Franklin Street Redevelopment Study Phase II
Public Workshop
October 1, 2014
Portland Public Library

Figure 1: Alignment proposal as shown at Oct. 1st Public Meeting

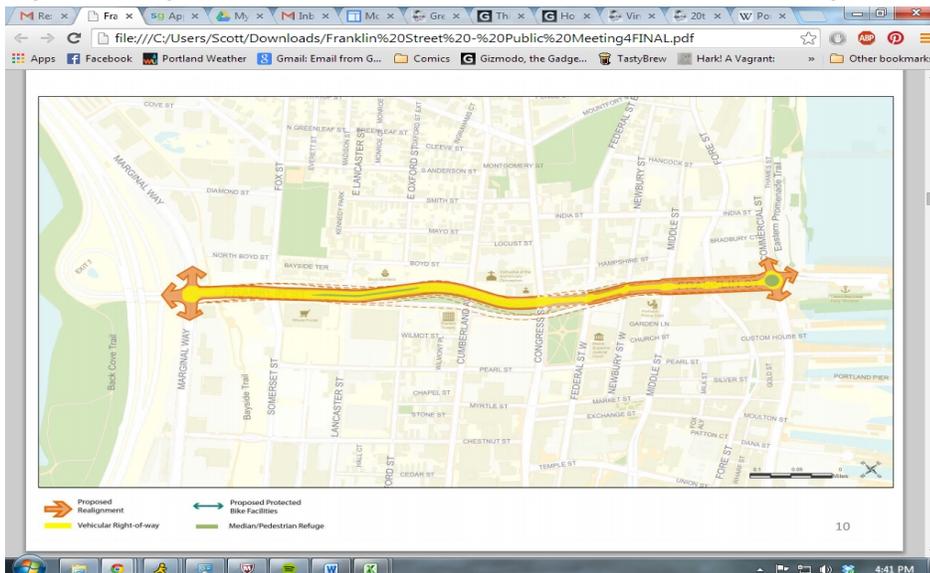
- Love the swerve and change in shape so less highway, more graceful
- Would like to see it narrower between Marginal and Congress.
- Narrower Franklin St. is fantastic idea!

- Alignment needs to be same throughout, creating a bottleneck at Lincoln is bad.
- Keeping Franklin to East to expand Lincoln Park is a preferred option.

- Really like “urban street” alignment. Will really add a lot to neighborhood quality of life.
- I think this bend (*arrow to kink between Oxford and Cumberland streets*) seems arbitrary and suburban – An urban grid is usually orthogonal.

Figure 2: Marginal Way intersection proposal as shown at Oct. 1st Public Meeting

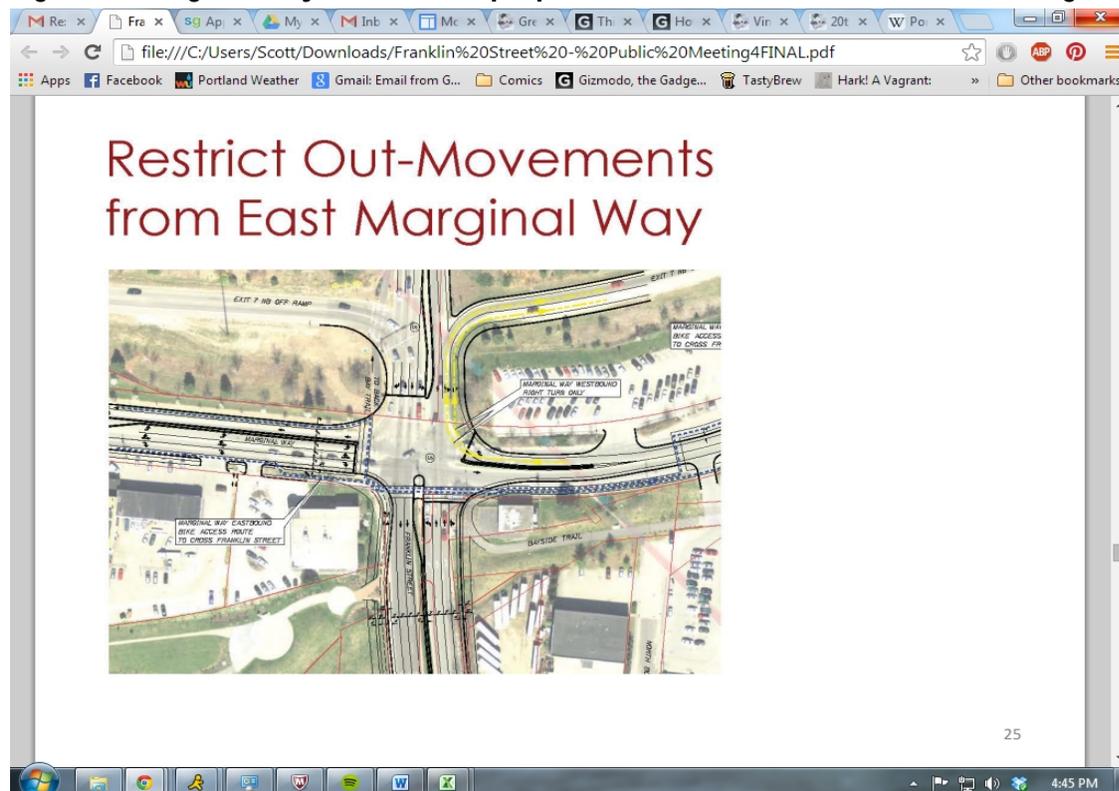
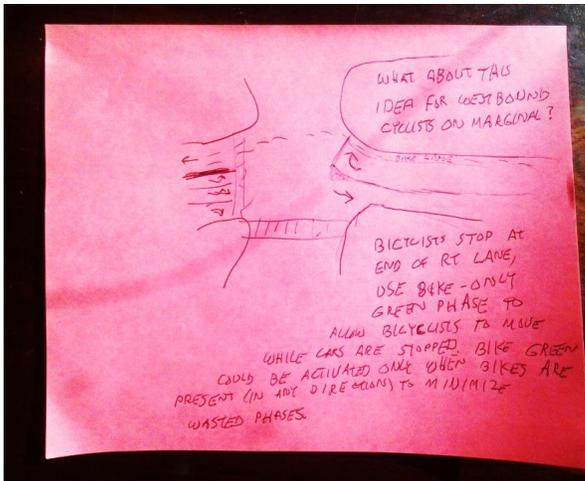
- This intersection should decrease pedestrian crossing distances, not increase them.
- This increases possibility of fatal accidents to ped/bike.
- This redesign should create a safe & convenient crossing (across Franklin) for people using the Bayside Trail.

- As a bicyclist I feel much less safe with this scenario. As a walker much, much less safe.
- This is much worse for bikes than it is now!
- We need a crosswalk across the north side where the highway comes in and goes out.

- This is too big! Policy gets to decide DESIRED road throughput not engineers.
- TOO BIG! If you build it they will come: cars not people/bikes.
- Don't widen 295 outbound ramp.

- Don't widen Franklin
- Do not like widening of any approach! Too difficult to cross. Ok with bridge crossing at bayside trail.
- 4 lanes is crazy
- Do not widen intersection

- Way too many lanes on Franklin St. to permit safe crossing. 8 lanes? Will the walk light be 2 minutes...
- Too wide and too complicated. This does not look like an improvement.
